Light is OSRAM

OS-IN-2020-032

Introduction of product updates for OSOLON P1616 and OSOLON Piccolo

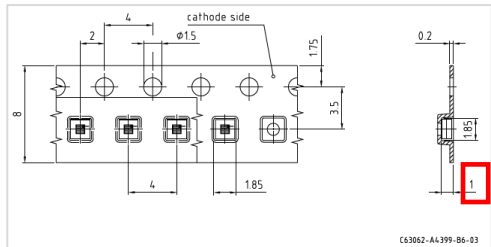
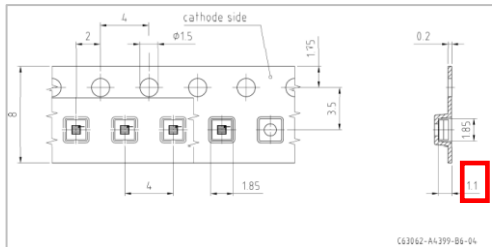
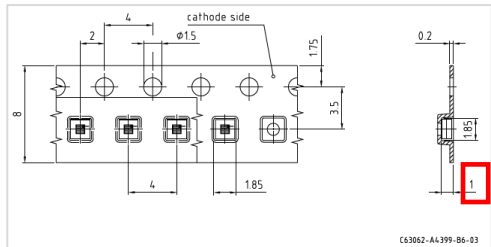
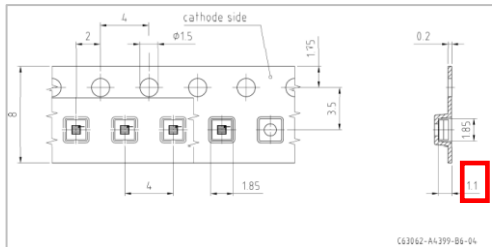
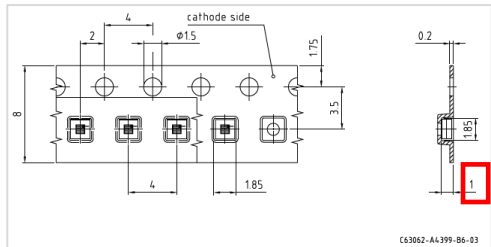
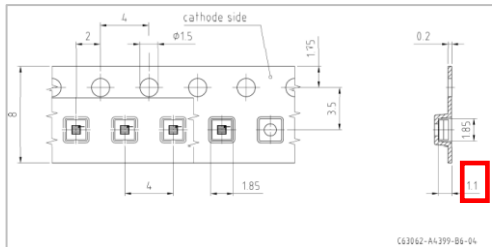
Objective	Introduction of product updates for OSOLON P1616 and OSOLON Piccolo		
Products affected	OSOLON P1616: SFH 4170S, SFH 4180S OSOLON Piccolo: SFH 4170S A01, SFH 4180S A01		
Background	<ul style="list-style-type: none"> • Introduction of rougher mold release foil at molding process to reduce risk of sticky units during pick & place process • Introduction of new carrier tape design to increase pocket height 		
	<table border="0" style="width: 100%;"> <tr> <td style="width: 50%; vertical-align: top;"> <p>Current status:</p> <p>Device appearance</p>  </td> <td style="width: 50%; vertical-align: top;"> <p>New status:</p> <p>Device appearance</p>  </td> </tr> </table>	<p>Current status:</p> <p>Device appearance</p> 	<p>New status:</p> <p>Device appearance</p> 
<p>Current status:</p> <p>Device appearance</p> 	<p>New status:</p> <p>Device appearance</p> 		
Realization	<table border="0" style="width: 100%;"> <tr> <td style="width: 50%; vertical-align: top;"> <p>Tape drawing</p>  <p>Pocket height: 1mm</p> </td> <td style="width: 50%; vertical-align: top;"> <p>Tape drawing</p>  <p>Pocket height: 1.1mm</p> </td> </tr> </table>	<p>Tape drawing</p>  <p>Pocket height: 1mm</p>	<p>Tape drawing</p>  <p>Pocket height: 1.1mm</p>

<p>Tape drawing</p>  <p>Pocket height: 1mm</p>	<p>Tape drawing</p>  <p>Pocket height: 1.1mm</p>		
Assessment	The datasheets will be updated accordingly by CW 01 / 2021. There is no change in the characteristics of the affected products.		
Time Schedule	Implementation: CW 01 / 2021
